Access Compliance Report

(Curb Ramps)

Intersection ID: 48560	Main Street: WOODLAND_WATCH_CT	Cross Street: ARDREY_WOODS_DR	Location:	N
ADA ID: 004BD9F88C54	Ramp Type: Perp	Initial Pass/Fail: Fail	Overall Compliance: No	Severity Score: 21.25
Codes/Mitigation Info/Possible Solution		Field Measurements/Component Compliance

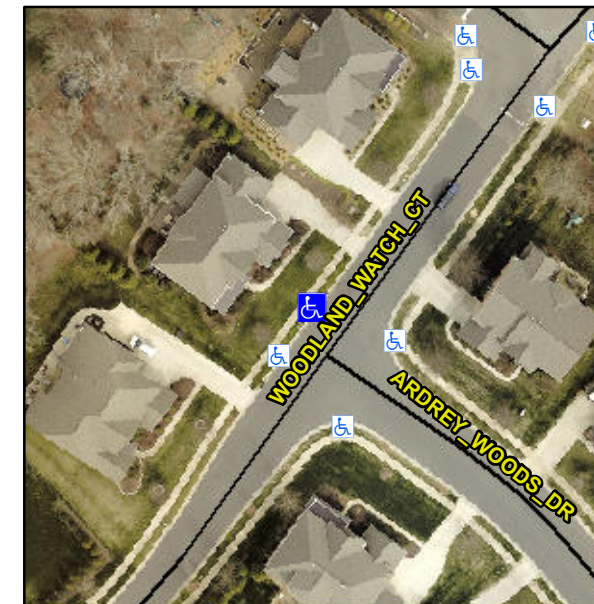
Not Found, R304.5.1, R304.5.3

Compliance	Description	Data	Compliance	Description	Data
N/A	Ramp Length (in)	46.0	Yes	Ramp Slope (%)	5.2
No	Ramp Width (in)	46.5	No	Ramp XSlope (%)	5.4
N/A	Flare Type LT	N/A	N/A	Flare Type RT	N/A
N/A	Flare Slope LT (%)	N/A	N/A	Flare Slope RT (%)	N/A
N/A	Flare Traversable LT?	N/A	N/A	Flare Traversable RT?	N/A
N/A	Landing Length (in)	N/A	N/A	DWS Provided?	N/A
N/A	Landing Width (in)	N/A	N/A	DWS Contrast?	N/A
N/A	Landing Slope (%)	N/A	N/A	DWS Length (in)	N/A
N/A	Landing X Slope (%)	N/A	N/A	DWS Full Width?	N/A
N/A	Landing Curb? (Y/N)	N/A	N/A	DWS Offset (in)	N/A
N/A	Shared Landing?	N/A			
N/A	Gutter Ponding?	N/A	N/A	Gutter Slope (%)	N/A
N/A	Gutter Lip Ht (in)	N/A	N/A	Gutter X Slope (%)	N/A
N/A	Painted X Walk1?	No	N/A	Painted X Walk2?	N/A
	X Walk 1 Direction	To SE		X Walk 2 Direction	N/A
N/A	X Walk 1 Width (in)	N/A	N/A	X Walk 2 Width (in)	N/A
	X Walk 1 Slope (%)	0.2		X Walk 2 Slope (%)	N/A
	X Walk 1 X Slope (%)	4.6		X Walk 2 X Slope (%)	N/A

Remove & Replace Entire Ramp.
